MEMORANDUM

FILE REF ACS Hillingdon International School, 108 Vine Lane, Hillingdon UB10 0BE

RESPONSE TO LB HILLINGDON CONSULTEEES

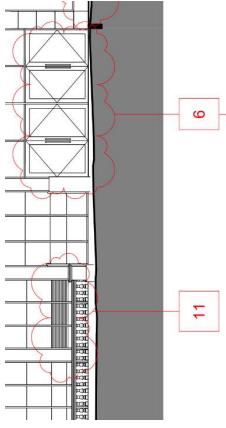
10	Please label the proposed location of the louvre, it could not be discerned from the drawings where the proposed location is.	See Cloud number 11 on page 18 of the Clouded Drawings set – this will be located at a low level on the front elevation of the existing building (shown on adjacent snippet)		
	11	A larger scale drawing of the hopper and downpipes on the west elevation is needed at 1:20 to assess the visual impact.	1:20 Elevation/Section provided to assess the impact.	1689-ID-PL-XX-DR-A-3062-P01 - Section - Rainwater Hopper & Downpipes	
	12	Relocation of tree accepted	Agreed	N/A	
Waste Services	13	Details required for waste storage and collection, including a swept path analysis for Refuse Collection Vehicle. A swept path analysis must be provided to demonstrate that collection vehicles will not reverse more than 12m, with entrance & exit in a forward motion being considered. The driver's line of sight to the storage must not be obstructed. Barriers to be in place where bins will closely pass parked cars. Bins should not cross parking bays, whether designated or otherwise.	Swept path analysis has been provided for a 10.5m front-loading refuse vehicle, indicating a 6.6m reverse required for egress. The school currently use this location for their refuse area and are seeking to regularise this change to make collections easier in the new location. Whilst the refuse vehicle is shown to cross two parking bays, due to the collection timings this occurs when no vehicles are present. Driver line of sight remains clear throughout the path and manoeuvre.	1689-ID-PL-XX-DR-A-1061-P01 - Site Swept Path - Refuse Collection 01
